Revision A Notes - 19.01.24

ev A 19/01/2024 Issued for Planning est Issue 29/06/2023 Issued for Planning

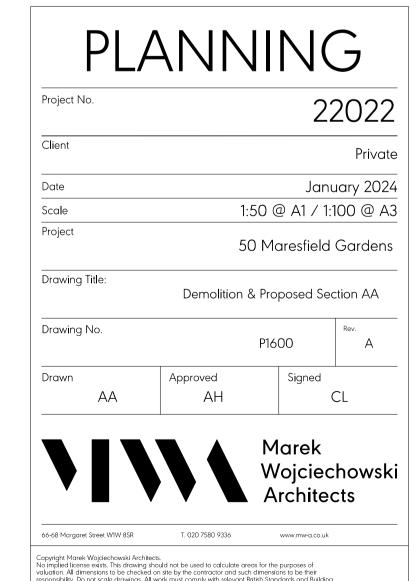
(01) East basement wall moved inwards to reduce basement area

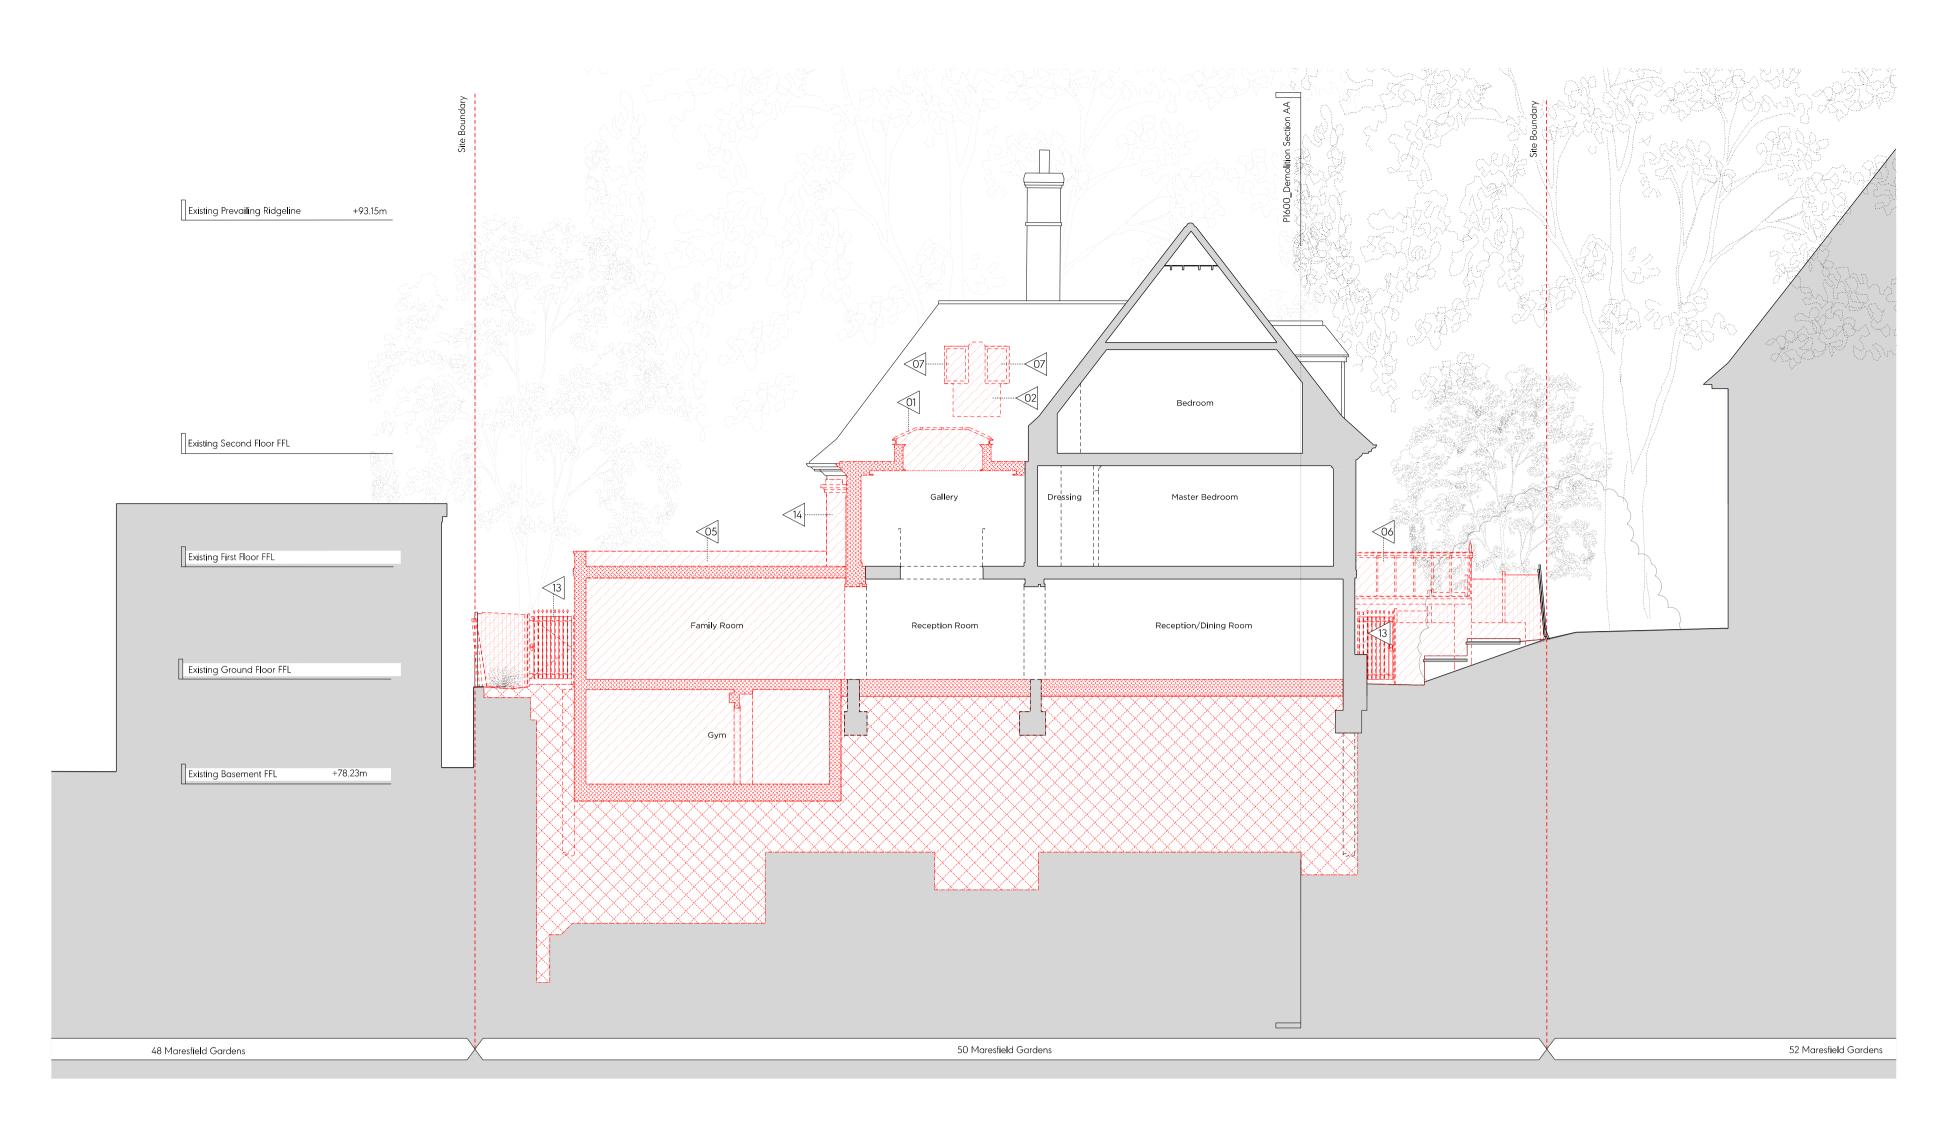
Garden wall stepped back water feature omitted and skyli moved to suit. Wall reduced in height to align with

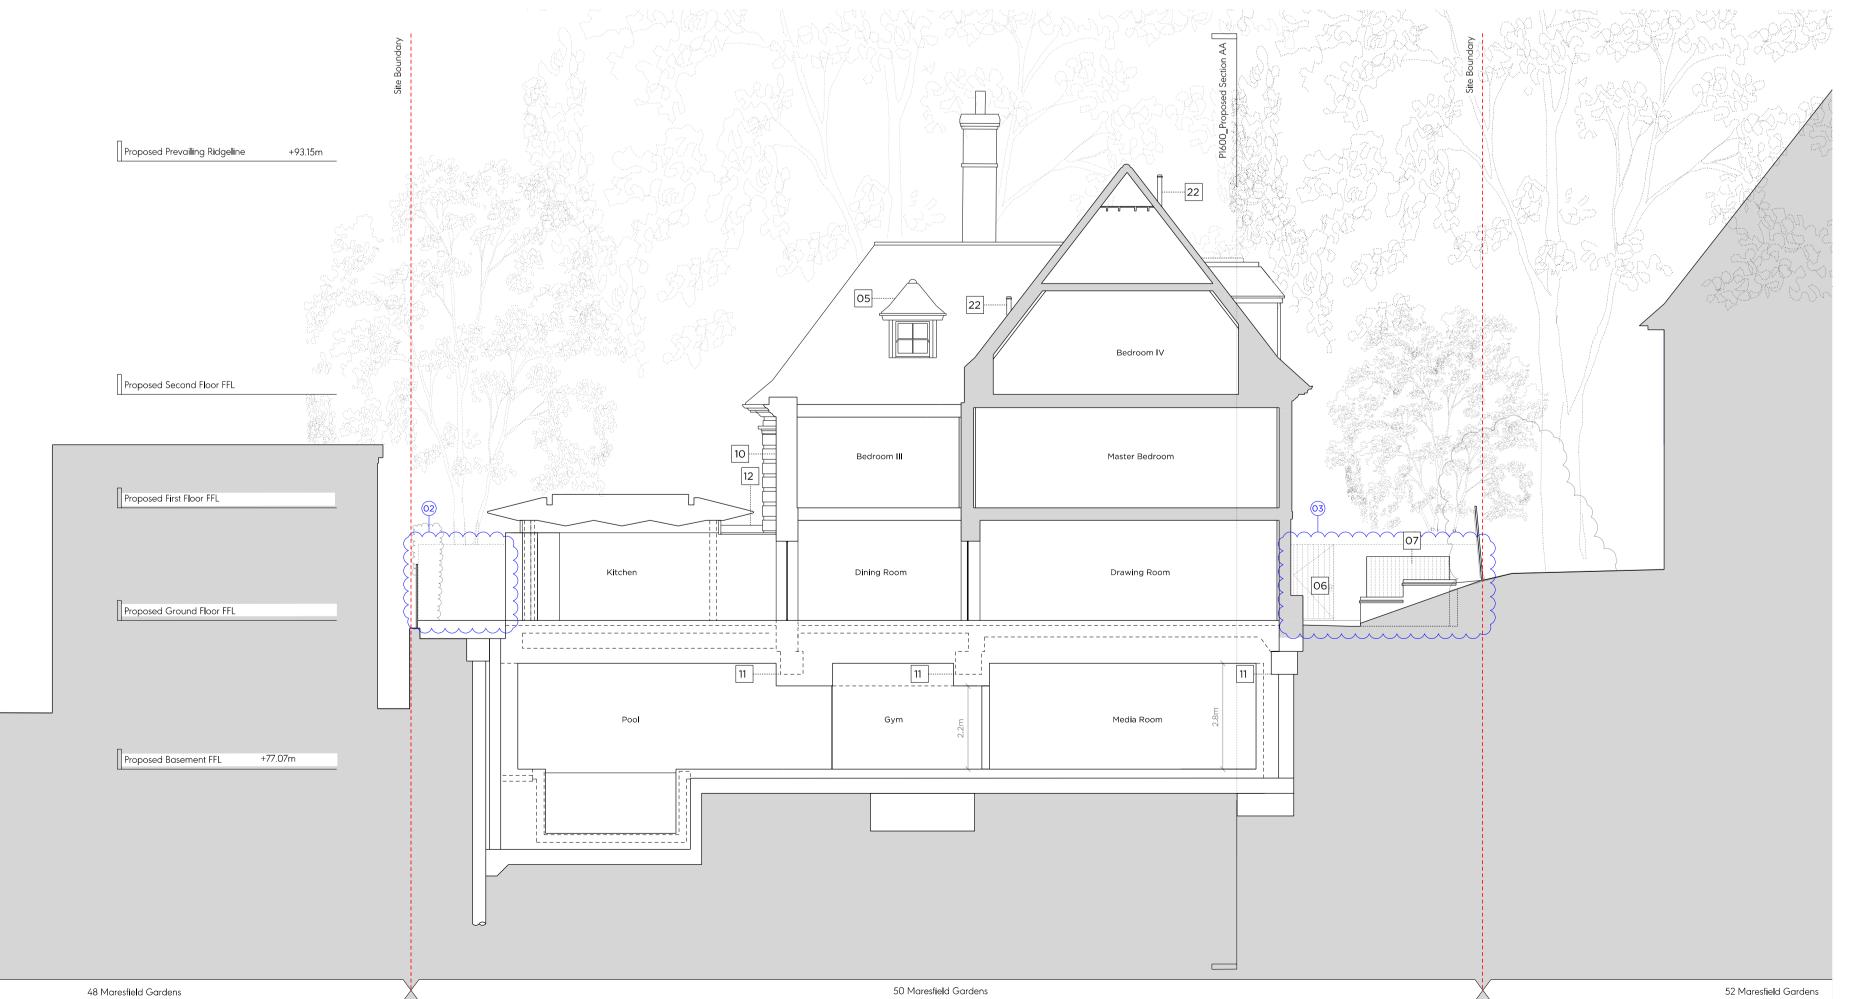
Garden wall reduced in height to align with the neighbouring (no.48) balcony
